Access Compliance Report Public Rights-of-Way (Curb Ramps)

Intersection ID: 47697Main Street:LEES_COURT_STCross Street:NIGHT_HERON_LNLocation:NWADA ID: 87AA57F34459Ramp Type:PerpInitial Pass/Fail:FailOverall Compliance:NoSeverity Score:12.5

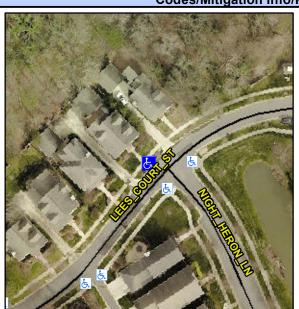
Possible Solutions:	<u>c</u>
Remove & Replace Entire Ramp.	N
	Y
	N
	N
	N
	N
Surveyor Notes:	N
N/A	N
	N.
	N
	N
PROW/ADA:	N
Not Found, R304.2.2	N.
	N
	N

Field Measurements/Component Compliance						
Compliance Description Data		Data	Comp	liance Description	Data	
N/A	Ramp Length (in)	121.0	No	Ramp Slope (%)	11.4	
Yes	Ramp Width (in)	49.0	Yes	Ramp XSlope (%)	0.2	
N/A	Flare Type LT	N/A	N/A	Flare Type RT	N/A	
N/A	Flare Slope LT (%)	N/A	N/A	Flare Slope RT (%)	N/A	
N/A	Flare Traversable LT?	N/A	N/A	Flare Traversable RT?	N/A	
N/A	Landing Length (in)	N/A	N/A	DWS Provided?	N/A	
N/A	Landing Width (in)	N/A	N/A	DWS Contrast?	N/A	
N/A	Landing Slope (%)	N/A	N/A	DWS Length (in)	N/A	
N/A	Landing X Slope (%)	N/A	N/A	DWS Full Width?	N/A	
N/A	Landing Curb? (Y/N)	N/A	N/A	DWS Offset (in)	N/A	
N/A	Shared Landing?	N/A				
N/A	Gutter Ponding?	N/A	N/A	Gutter Slope (%)	N/A	
N/A	Gutter Lip Ht (in)	N/A	N/A	Gutter X Slope (%)	N/A	
N/A	Painted X Walk1?	No	N/A	Painted X Walk2?	N/A	
	X Walk 1 Direction	To SE		X Walk 2 Direction	N/A	
N/A	X Walk 1 Width (in)	N/A	N/A	X Walk 2 Width (in)	N/A
